**ZONING AMENDMENT,
PLANNED UNIT DEVELOPMENT &
SUBDIVISION STAFF REPORT**

| <u>SUBDIVISION NAME</u> | Kirby Subdivision |
| <u>LOCATION</u> | 7049 Dickens Ferry Road and 7060 & 7068 Airport Boulevard (North side of Airport Boulevard extending to the South side of Dickens Ferry Road, 550'± East of Cody Road) |
| <u>CONTEMPLATED USE</u> | Rezoning from R-1, Single-Family Residential District, to B-3, Community Business District, to eliminate split zoning, Planned Unit Development Approval to allow multiple buildings on a single building site and share access between two building sites, and a Subdivision to create one legal lot of record from a single metes-and-bounds parcel. It should be noted, however, that any use permitted in the proposed district would be allowed at this location if the zoning is changed. Furthermore, the Planning Commission may consider zoning classifications other than that sought by the applicant for this property. |

SUBDIVISION AND ZONING DETAIL

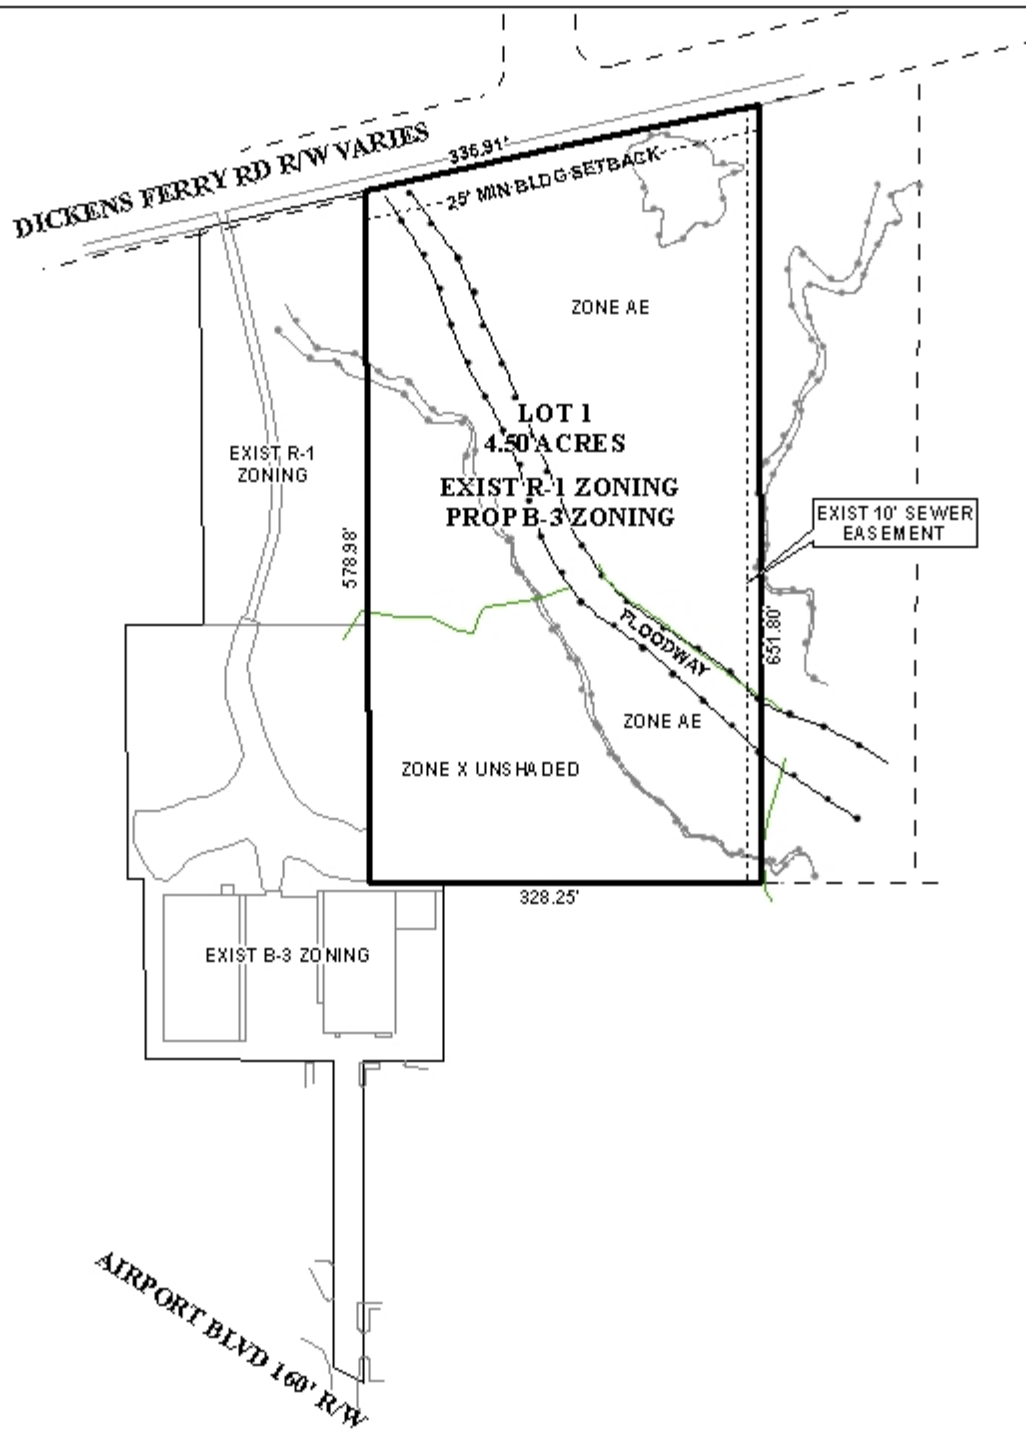
The proposed 1.4± acre, 1-lot subdivision fronts Dickens Ferry Road, a minor road without curb and gutter, which requires a 60-foot of right-of-way Section V.B.14. of the Subdivision Regulations. The preliminary plat states that the right-of-way varies; therefore dedication should be made to provide 30-feet from the centerline if necessary.

Due to the location and size of the development, access management is a concern. The site plan illustrates the subject site as having one curb-cut to Airport Boulevard, and an existing dirt drive that connects to Dickens Ferry 1 of Spectrum Subdivision should be denied, as well as for the proposed Lot 1. The existing drive to Dickens Ferry should be removed.

The site plan provided does not illustrate any parking on the site, nor does it provide any information regarding landscaped area, tree plantings, what type of business occupies each of the existing structures, or if the site will use a dumpster or curb-side service. The site plan should be revised to include this information, as well as any other information indicating compliance with the Zoning Ordinance.

The preliminary plat does not depict the 25' minimum building setback line for the proposed Lots 1 as required by Section V.D.9. of the Subdivision Regulations. This setback should be depicted on the Final Plat, if approved.

- 1) illustrate dedication if necessary to provide 30' from the centerline of Dickens Ferry Road;
- 2) inclusion of Lot 1, Spectrum Subdivision in the rezoning request, or removal of the same lot from the Planned Unit Development;

- 3) inclusion of adjacent and nearby lots fronting Airport Boulevard that have shared access, or revision of the site plan to illustrate that the shared access has been eliminated;

- 4) placement of a note stating the development is denied access to Dickens Ferry Road;
- 5) placement of a note stating that no structures are to be built in any easement;

- 6) illustration of parking spaces;
- 7) provide information about the types of businesses in each existing structure, and their sizes;
- 8) provide landscaping and tree planting calculations;

- 9) illustration of a dumpster compliant with Section 64-4.D.9 of the Zoning Ordinance, or place a note that curb side pick-up will be utilized;
- 10) illustration of the required residential buffer per Section 64-4.D.1. of the Zoning Ordinance;

- 11) illustration of the 25' minimum building setback along all street frontages;
- 12) compliance with Engineering comments (*Any work performed in the existing ROW (right-of-way) such as driveways, sidewalks, utility connections, grading, drainage, irrigation, or landscaping will require a ROW permit from the City of Mobile Engineering Department (208-6070) and must comply with the City of Mobile Right-of-Way Construction and Administration Ordinance (Mobile City Code, Chapter 57, Article VIII). Any and all proposed land disturbing activity will need to be in conformance with the Storm Water Management and Flood Control Ordinance (Mobile City Code, Chapter 17, Ordinance #65-007 & #65-045); the City of Mobile, Alabama Flood Plain Management Plan (1984); and, the Rules For Erosion and Sedimentation Control and Storm Water Runoff Control. A complete set of construction plans including, but not limited to, drainage, utilities, grading, storm water detention systems, paving, and all above ground structures, will need to be included with the Land Disturbance permit. This Permit must be submitted, approved, and issued prior to beginning any of the construction work. Add a note to the Plat stating that the proposed development must comply with all Engineering Department Policy letters.*);
